DOE/EIS-0269

**FINAL PROGRAMMATIC ENVIRONMENTAL IMPACT STATEMENT FOR
ALTERNATIVE STRATEGIES FOR THE LONG-TERM MANAGEMENT AND USE
OF DEPLETED URANIUM HEXAFLUORIDE**

Volume 3: Responses to Public Comments

April 1999

Figure 1

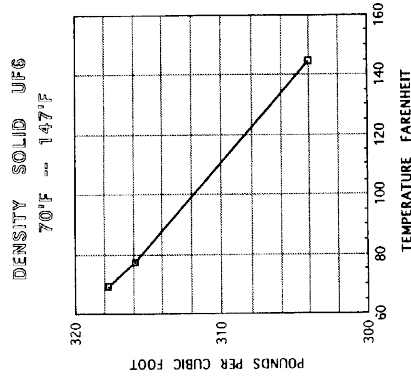
When the cylinder is filled with liquid UF₆ to its proper fill limit, and has cooled to room temperature, based on the data in Figure 1, showing the density at 68°F to be 317.8 lbs/ft³, the solid UF₆ will occupy 26,840 lbs/317.8 lbs/ft³ = 84.45 ft³/139 ft³ = 61% of the certified minimum volume. The remaining 39% of the volume will be filled with UF₆ gas at subatmospheric pressure or vacuum.

Figure 2

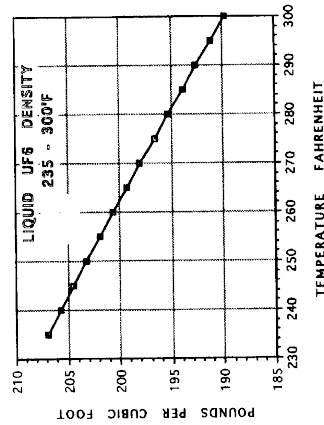
From ANSI N14.1, the minimum volume for a 48G cylinder is 139 ft³ and from Figure 2, the density of liquid UF₆ at 250°F is 203.7 lbs/ft³. For a 48G cylinder the calculation of the fill limit is:
 95%(139 ft³) (203.3lbs/ft³ of UF₆) = 26840 lbs of UF₆
